SR 105/US 441 Business
Interchange Widening Improvements
STP-2640(10), P.I. 132100
Habersham County, Georgia

Value Engineering Study Report
Preliminary Design Stage

January 2008

DESCRIPTION: **USE A 10-FT. URBAN SHOULDER THROUGHOUT PROJECT** SHEET NO.: **1 of 6**

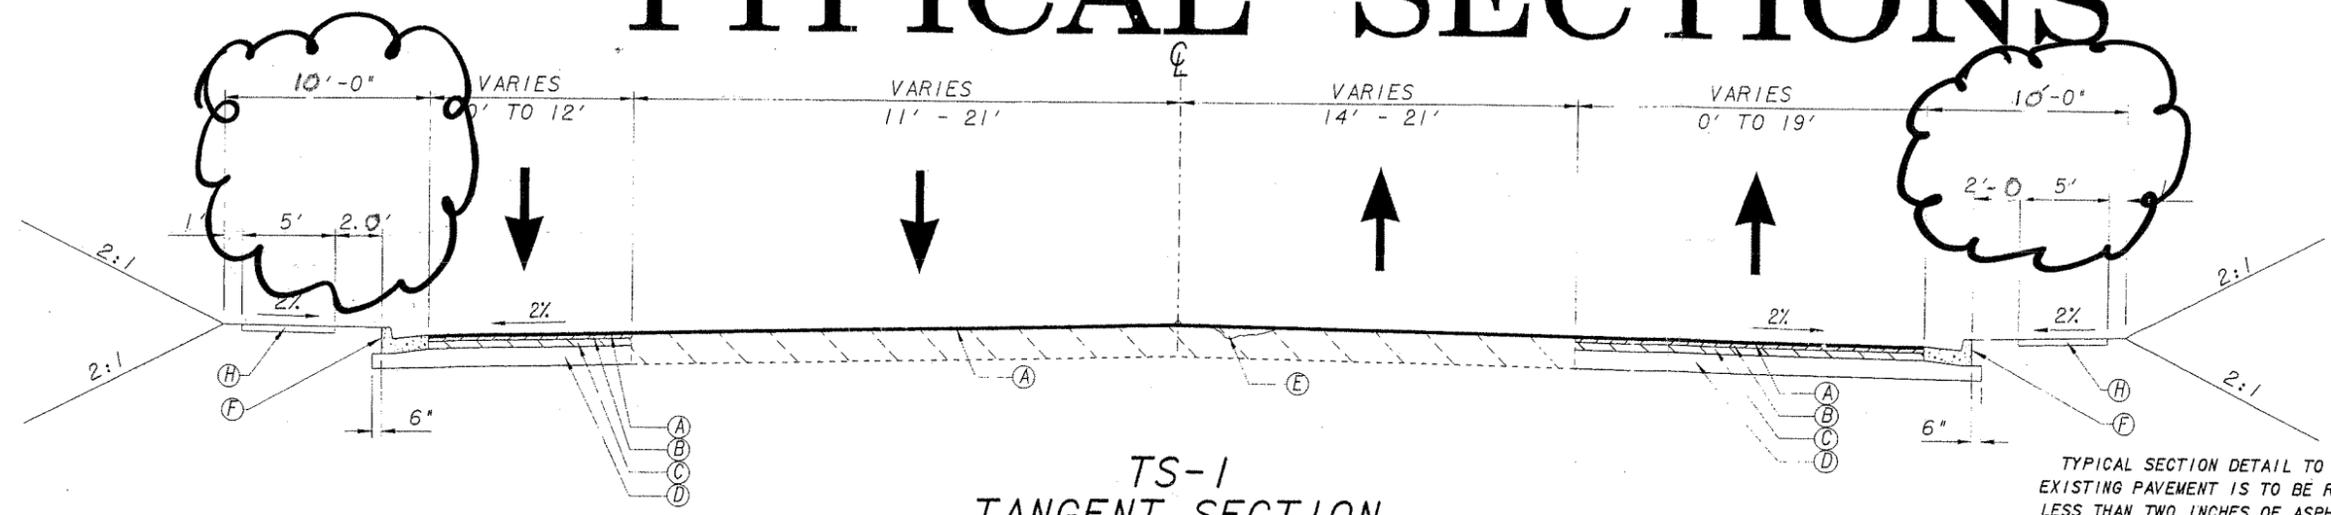
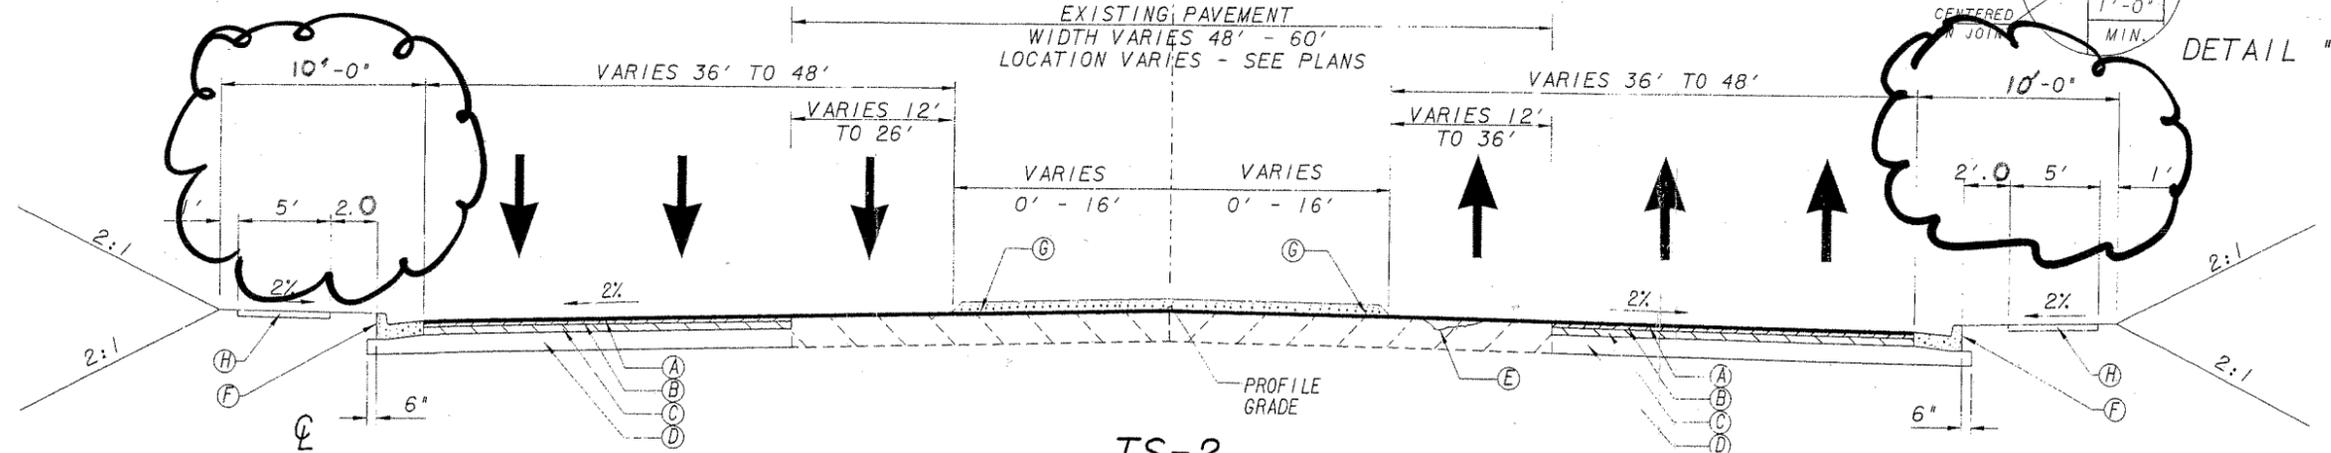
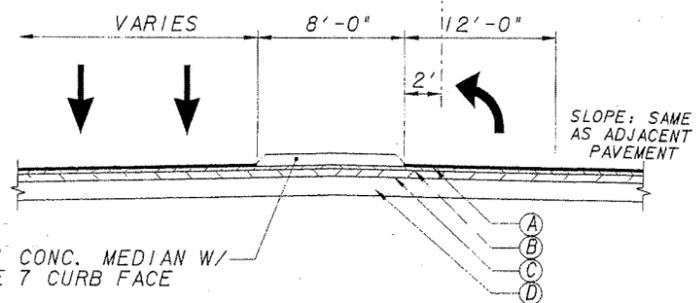
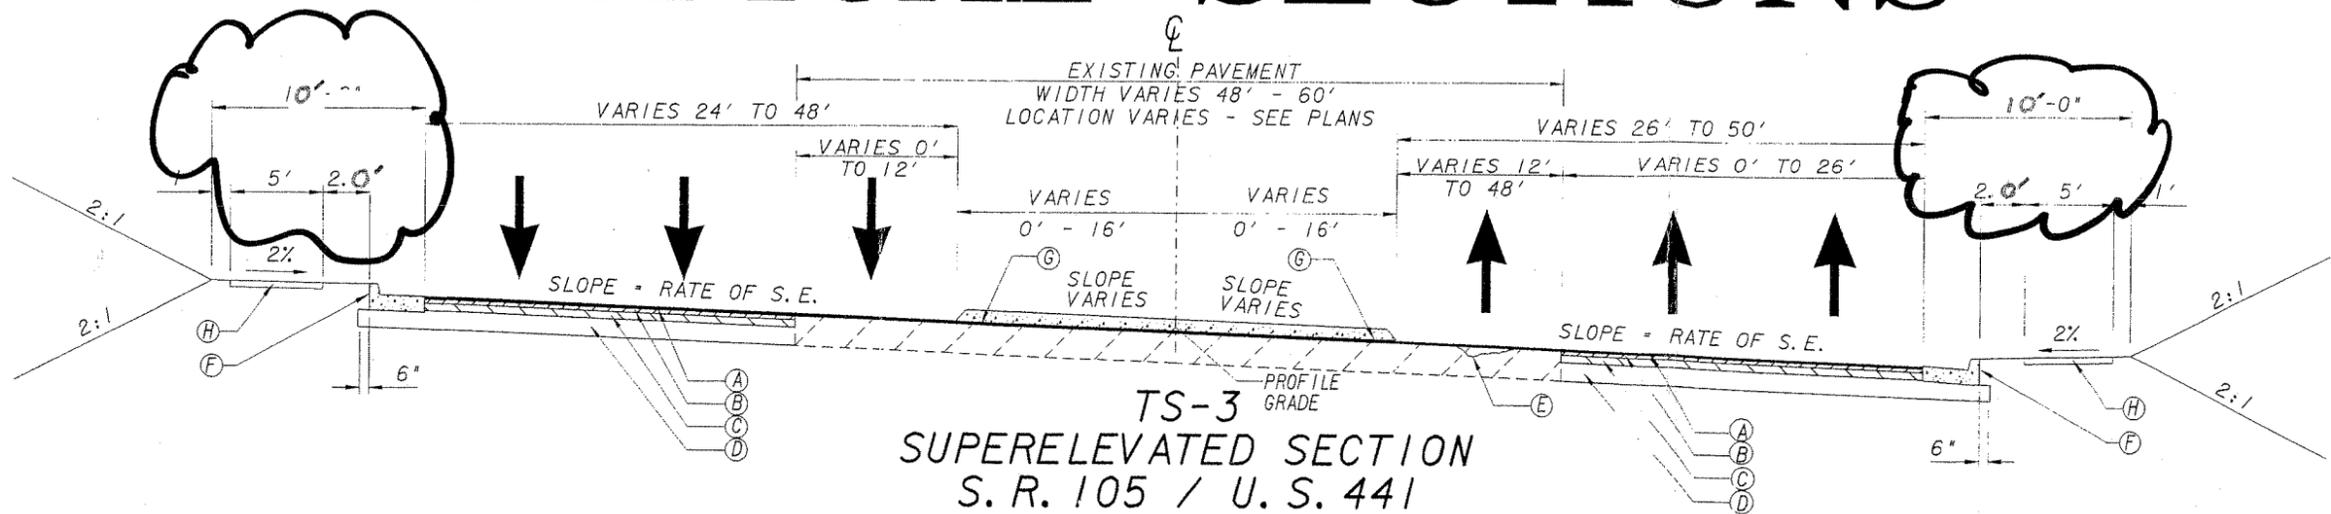
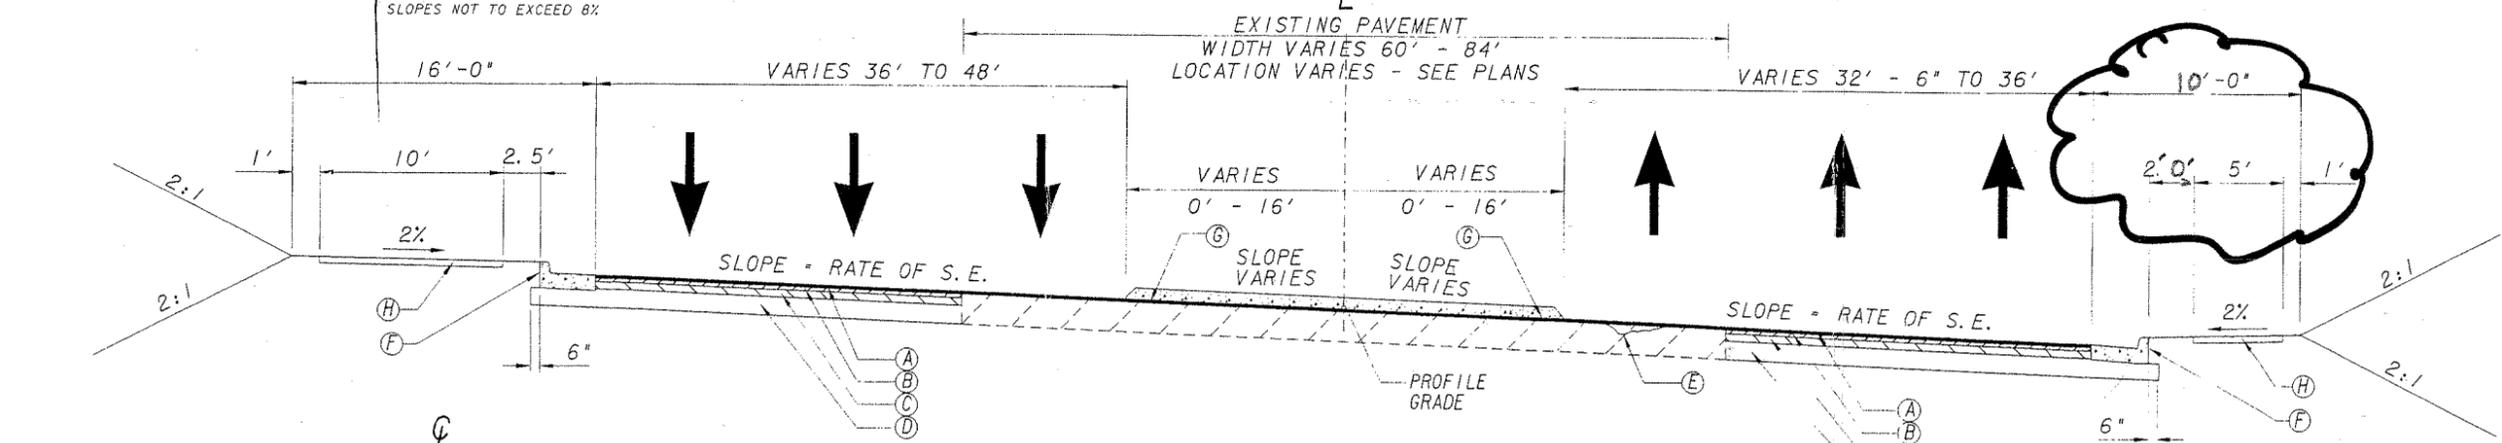
The original typical section indicates an 11-ft. shoulder on the north side that transitions to a 16-ft. shoulder on the north side of the mainline alignment. The south side alignment indicates an 11-ft. shoulder that transitions to a 10.5-ft. shoulder, per the typical sections in the plans.

The reduction of shoulder will provide fewer right of way impacts to both the mainline alignment and side streets. The reduction of 30-in. curb and gutter will make for an even 10-ft. shoulder on the south side of the mainline alignment.

ALTERNATIVE NO.: **TS-10**

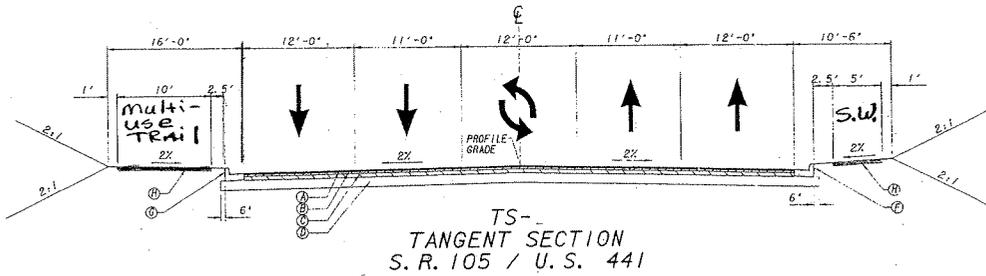
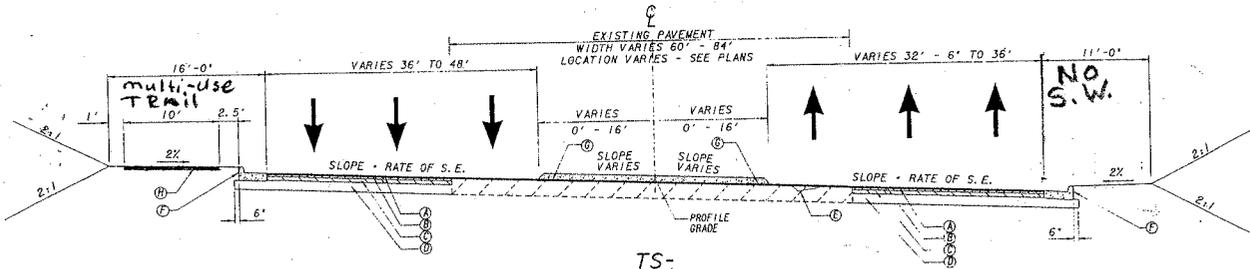
This alternative proposes to save construction costs by using the 10-ft. multi-use trail and not provide for an additional sidewalk on the opposite shoulder. The right shoulder would still be graded to the proposed width so others (local government or developments) could build a sidewalk later if so desired.

TS-11

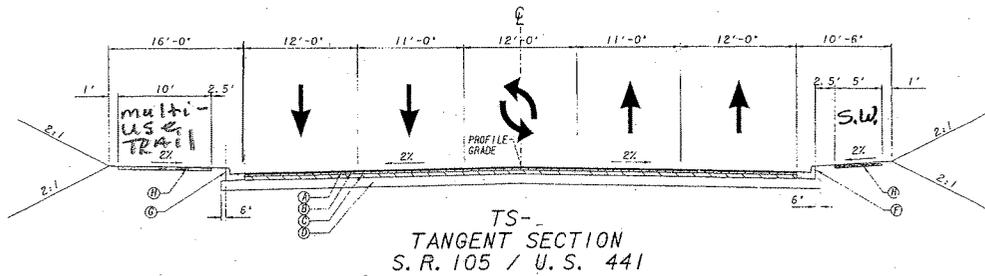
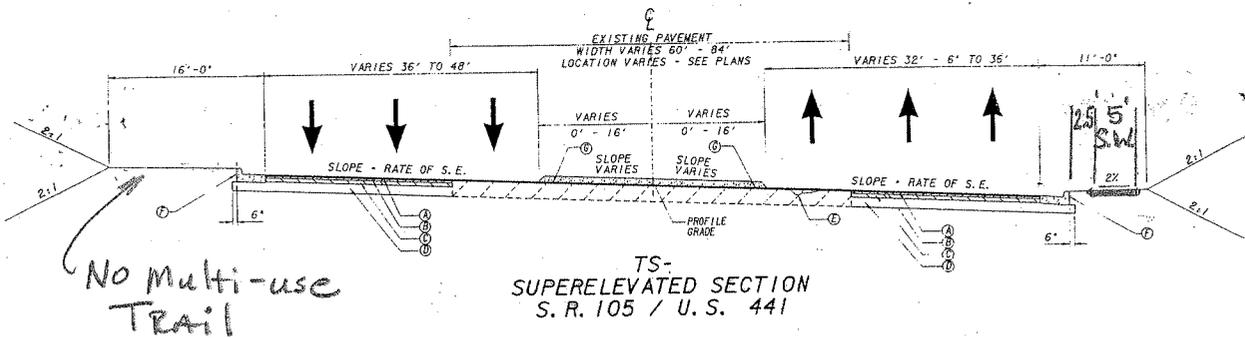
DESCRIPTION: **DELAY THE PAVING OF THE MULTI-USE TRAIL, GRADE** SHEET NO.: **1 of 4**
ONLY

ALTERNATIVE NO.: TS-12

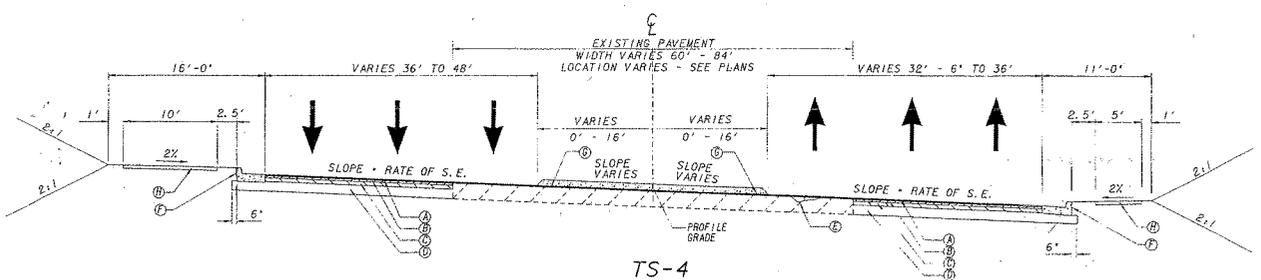
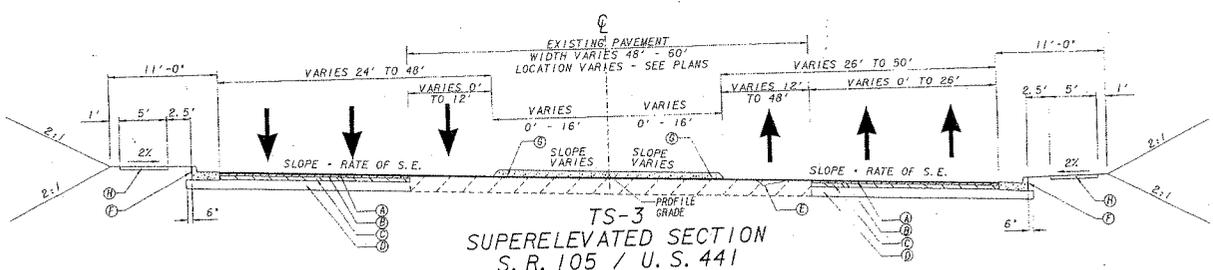
Provide 5-ft. sidewalks on both sides. However, grade the left-side shoulder to provide for a future 10-ft. multi-use trail by adding 5 ft. to the shoulder.
